CRIME IMPACT STATEMENT

SILVERWOOD HOUSE, 129 BARLOW MOOR ROAD, DIDSBURY, MANCHESTER

RESIDENTIAL (10 no. APARTMENTS & 7 no. HOUSES)

REFERENCE:2016/0123/CIS/01

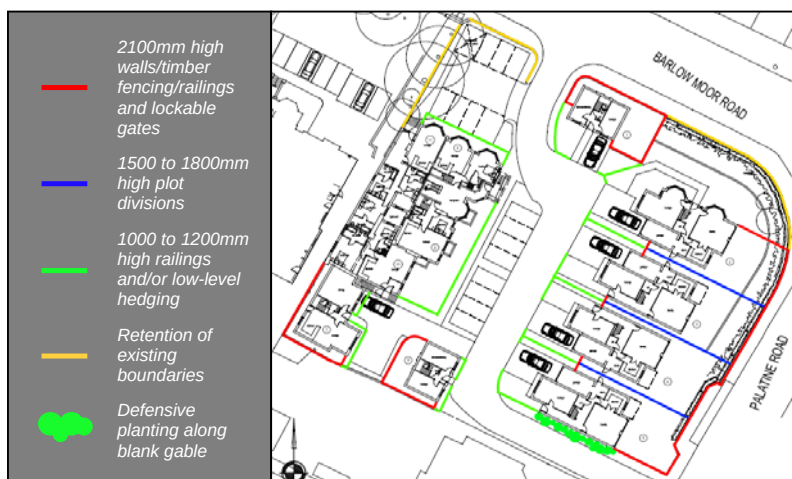
- 3.3.1 The boundary treatments to the proposed houses and apartment building are vitally important to secure them, any parked vehicles and prevent unauthorised access to private spaces (see opposite for illustration and Section 4.6 for more details). The sides and rears of the houses should be defined as private space and adequately secured to prevent unauthorised access, particularly robustly where adjacent to publicly accessible space (hedging is not

-
- considered adequate for securing private spaces). The front elevations of all of the houses and the apartment building should be protected and defined by some defensible space (defined by low-level railings and/or low-level, dense hedging) - creating small areas in front of each property entirely separate from the shared space and in ownership/control of the residents themselves, providing protection to accessible windows from unauthorised access, nuisance and anti-social behaviour (see Section 4.6). All basement lightwells should also be enclosed with railings to prevent unauthorised access and there should be no external doors at basement level that are publicly accessible.

- 3.3.2 Consideration should be given to re-orientating the front entrance of Plot 2 so that it fronts onto the shared space/access road, where visitors to the property would be better overlooked, allowing the sides and rear of the property to be enclosed and defined as private space (where partially hidden windows/doors could be attacked unseen). If it is to remain as currently proposed, the boundaries should be defined as shown above and consideration should be given to lowering/thinning the existing vegetation and tree foliage to the frontage of the site in front of the dwelling (as well in front of the apartment building/parking area to the west) to allow views of and from the dwelling frontages and the street.

- 3.3.3 As proposed, the gable end wall of Plot 5 (adjacent to the site entrance) will not be protected by any defensible space. As such, it may be vulnerable to loitering/gathering, nuisance and anti-social behaviour. It is highly recommended that, if possible, the gable wall is incorporated into either the front or the rear garden spaces of the dwelling. If this is unachievable, the gable wall should be protected by a defensive planting bed (as shown above) to deter casual access. It is also highly recommended that there is a symbolic barrier at the access/egress points off Barlow Moor Road/Palatine Road (e.g. brick pillars, change of road surface texture/colour etc.) to encourage a feeling of territoriality among the residents, psychologically giving the impression that the area beyond is private and discouraging anyone without a legitimate purpose from entering.
